January 11, 2000

SUBJECT: REPORT OF CONFIRMATORY ACTIVITIES FOR THE QUIVIRA MINING COMPANY-AMBROSIA LAKE FACILITY WINDBLOWN TAILINGS DECOMMISSIONING PROGRAM, GRANTS, NEW MEXICO (DOCKET NO. 40-8905; RFTA NO. 99-041)

**REPORT OF CONFIRMATORY ACTIVITIES FOR THE
QUIVIRA MINING COMPANY-AMBROSIA LAKE FACILITY
WINDBLOWN TAILINGS DECOMMISSIONING PROGRAM
GRANTS, NEW MEXICO**

FIGURE 7: Quivira Mining Company – Measurement and Sampling Locations

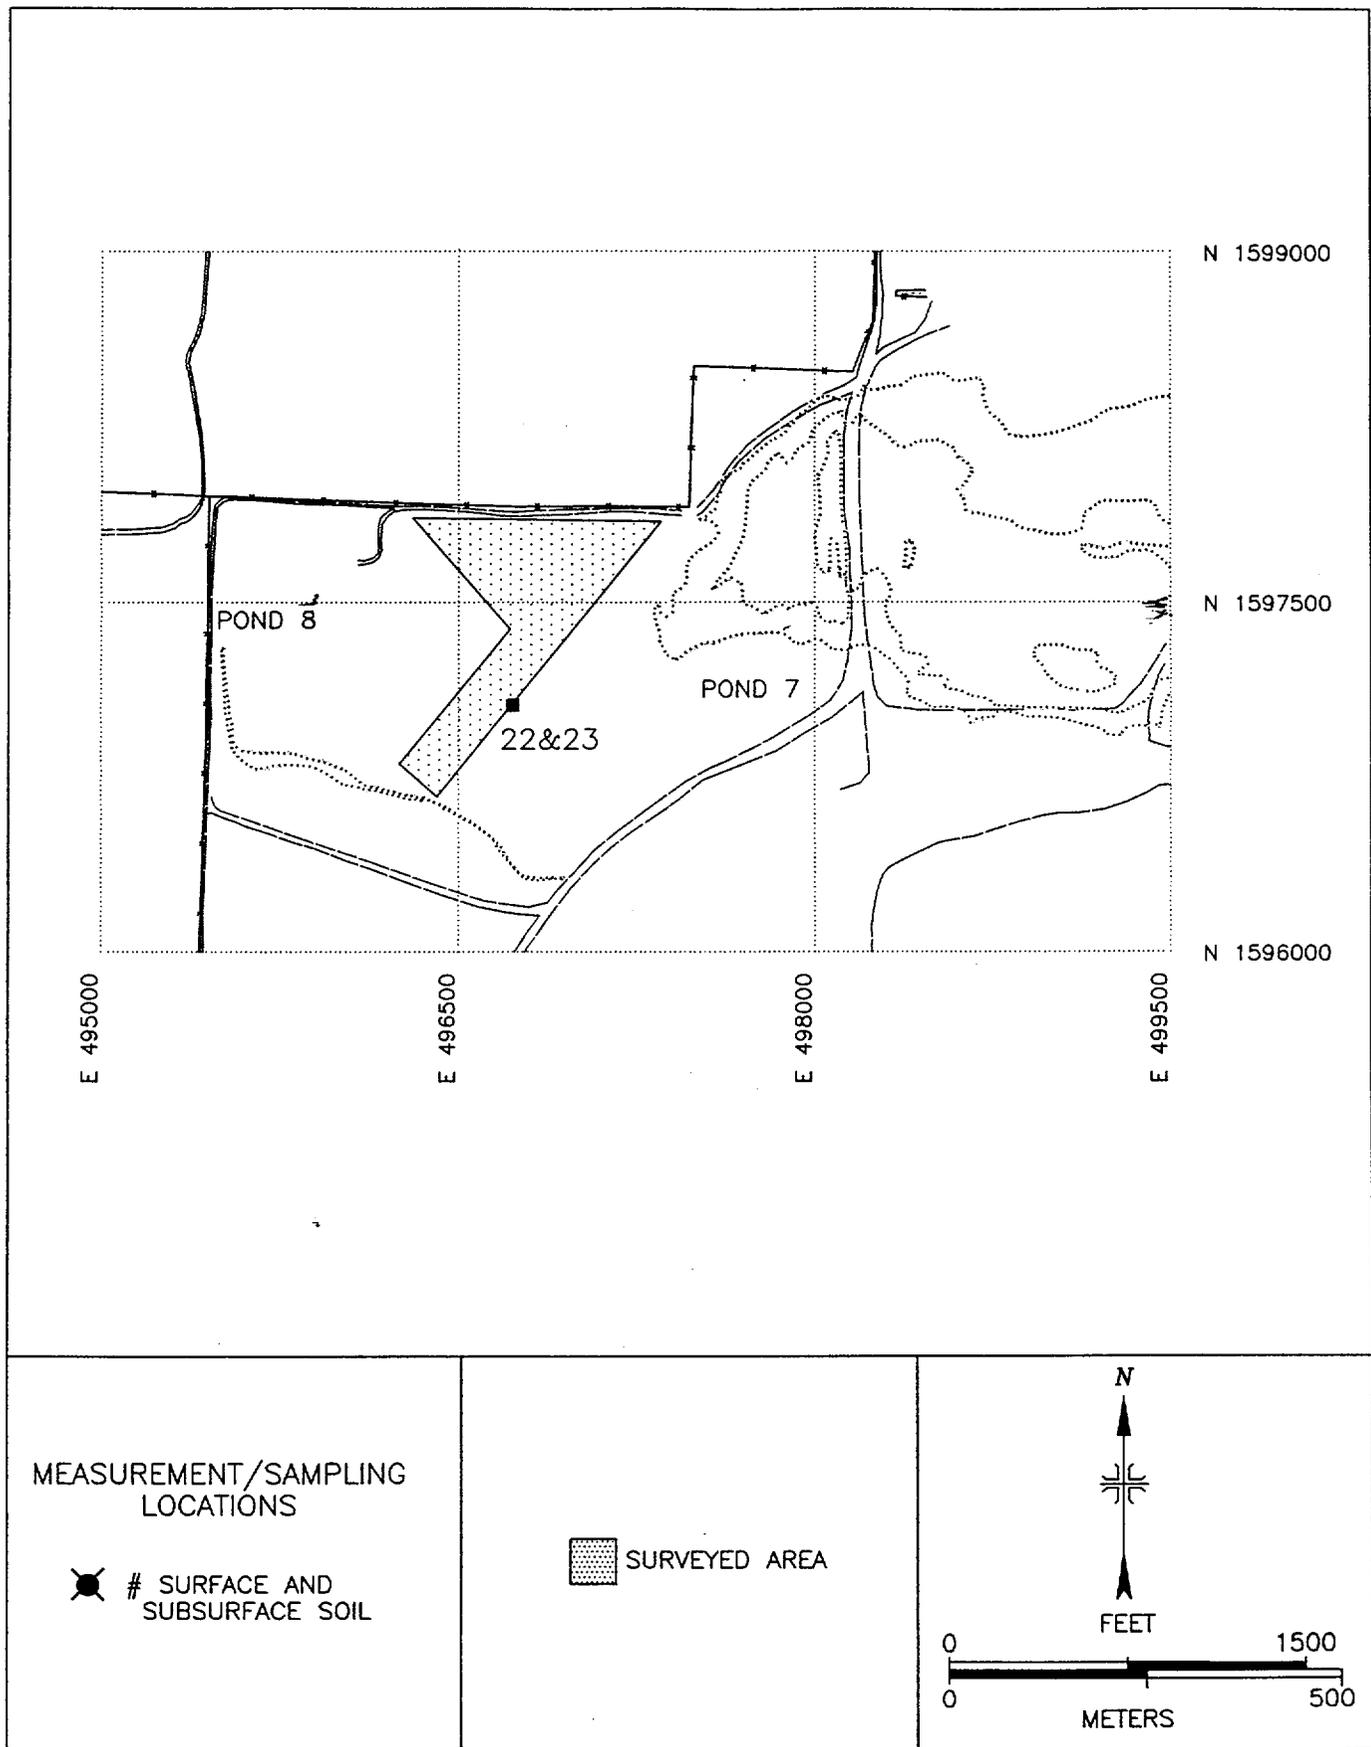
- Confirmatory gamma surveys were performed over four windblown tailings areas. Surveyed areas are shown on Figures 4 through 7. Surveys of these areas consisted of gamma surface scans using NaI scintillation detectors coupled to ratemeters with audible indicators. The distance between the detector and the ground surface was maintained at a minimum—nominally about 10 centimeters. Within each area surveyed, parallel one meter-wide detector scan paths were traversed for the entire length of the area. Scan paths were walked at intervals of every 10 to 20 meters across each surveyed area. Areas of elevated direct radiation in excess of the ambient background by a factor of greater than two times were marked and 100 % of the surrounding area was scanned. There were numerous such areas identified while performing the gamma scans. Sixteen representative anomalous areas identified were then selected for soil sampling. Samples were collected from the center of each selected anomaly and from four points equidistance between the center and what would be the corners of a 10 m × 10 m area, and field composited. Within Ponds 4, 5, and 8, general area gamma measurements were made while traversing each pond from end-to-end. General elevated gamma activity up to 10 times ambient background was noted throughout each of the ponds. Composite soil samples as described above were collected from three locations each in Ponds 4 and 5. For Pond 8 which had been remediated and backfilled, a composite sample was collected from one location at the surface (0 to 15 cm) and then a composite subsurface (15 to 30 cm) sample collected. Figures 5 through 7 show soil sampling locations. Exposure rate measurements were determined not to be required with the NRC representative's concurrence.
